Access Compliance Report

Public Rights-of-Way

Intersection ID: 28118	Main Street: DARBY_CHASE_DR	Cross Street: KENSWORTH_CT	Location: SW
ADA ID: ABDEFBA5AA4E	Ramp Type: Perp	Initial Pass/Fail: Fail	Overall Compliance: No
Severity Score: 50			
Codes/Mitigation Info/Possible Solution		Field Measurements/Component Compliance

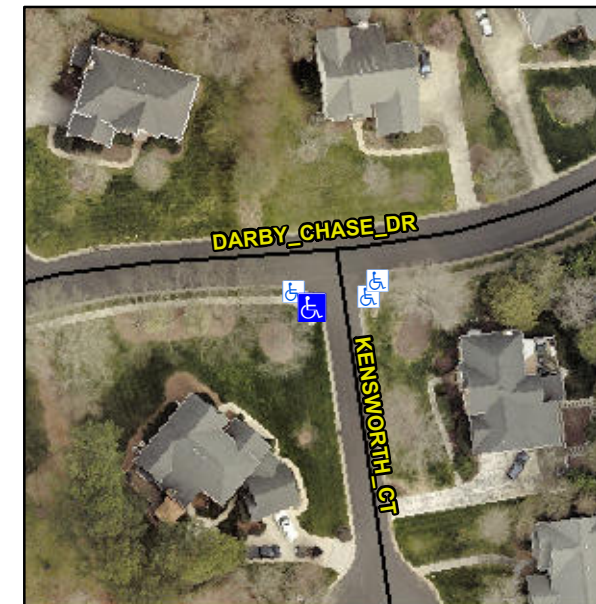
Not Found, R304.5.1, R302.7

Compliance	Description	Data	Compliance	Description	Data
N/A	Ramp Length (in)	44.5	Yes	Ramp Slope (%)	7.6
No	Ramp Width (in)	25.0	Yes	Ramp XSlope (%)	0.0
N/A	Flare Type LT	N/A	N/A	Flare Type RT	N/A
N/A	Flare Slope LT (%)	N/A	N/A	Flare Slope RT (%)	N/A
N/A	Flare Traversable LT?	N/A	N/A	Flare Traversable RT?	N/A
N/A	Landing Length (in)	N/A	N/A	DWS Provided?	N/A
N/A	Landing Width (in)	N/A	N/A	DWS Contrast?	N/A
N/A	Landing Slope (%)	N/A	N/A	DWS Length (in)	N/A
N/A	Landing X Slope (%)	N/A	N/A	DWS Full Width?	N/A
N/A	Landing Curb? (Y/N)	N/A	N/A	DWS Offset (in)	N/A
N/A	Shared Landing?	N/A			
N/A	Gutter Ponding?	N/A	N/A	Gutter Slope (%)	N/A
N/A	Gutter Lip Ht (in)	N/A	N/A	Gutter X Slope (%)	N/A
N/A	Painted X Walk1?	No	N/A	Painted X Walk2?	N/A
	X Walk 1 Direction	To E		X Walk 2 Direction	N/A
N/A	X Walk 1 Width (in)	N/A	N/A	X Walk 2 Width (in)	N/A
	X Walk 1 Slope (%)	2.9		X Walk 2 Slope (%)	N/A
	X Walk 1 X Slope (%)	1.6		X Walk 2 X Slope (%)	N/A

N/A	Ramp inside XWalk1?	N/A	N/A	Ramp inside XWalk2?	N/A
	Road Slope (%)	N/A	N/A	Clear Space?	N/A
	Road X Slope (%)	N/A	N/A	Clear Space to XWalk (in)	N/A
N/A	Any Obstructions?	N/A	N/A	Storm Grate/Utility Hazard?	N/A
	Obstruction Type			Storm Grate/Utility Type	
		N/A			N/A
		No		Surface Condition? (G/P)	Poor

Remove & Replace Entire Ramp.
